NEW KIT STOPS THE DRIP

NOTICED AN
OIL LEAK UNDER
THE ENGINE OF
YOUR M1151- OR
M1165-SERIES
HMMWV LATELY,
DRIVERS? THE
CULPRIT COULD
BE A LEAKING
OIL COOLER.

Engine oil cooler line rubs against splash shield

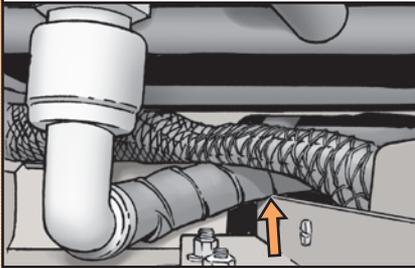
THE FORWARD-MOUNTED ENGINE OIL COOLER LINE, NSN 5730-01-594-2571, IS RUBBING AGAINST THE DRIVER'S SIDE SPLASH SHIELD AND BRACKET ASSEMBLY ON THESE VEHICLES.

IN TIME, A HOLE IS RUBBED IN THE OIL COOLER LINE THAT CAN GROW TO A CLASS III LEAK. IF THE LEAK GOES UNDISCOVERED, YOU COULD END UP WITH A BURNED OUT ENGINE.

TACOM HAS DEVELOPED A MODIFICATION KIT WITH INSTALLATION INSTRUCTIONS THAT REPLACES AND REPOSITIONS THE ENGINE OIL COOLER LINE TO STOP THE RUBBING.

THE
MOD KIT
NSN 2990-01-611-6140
PN 57K6188
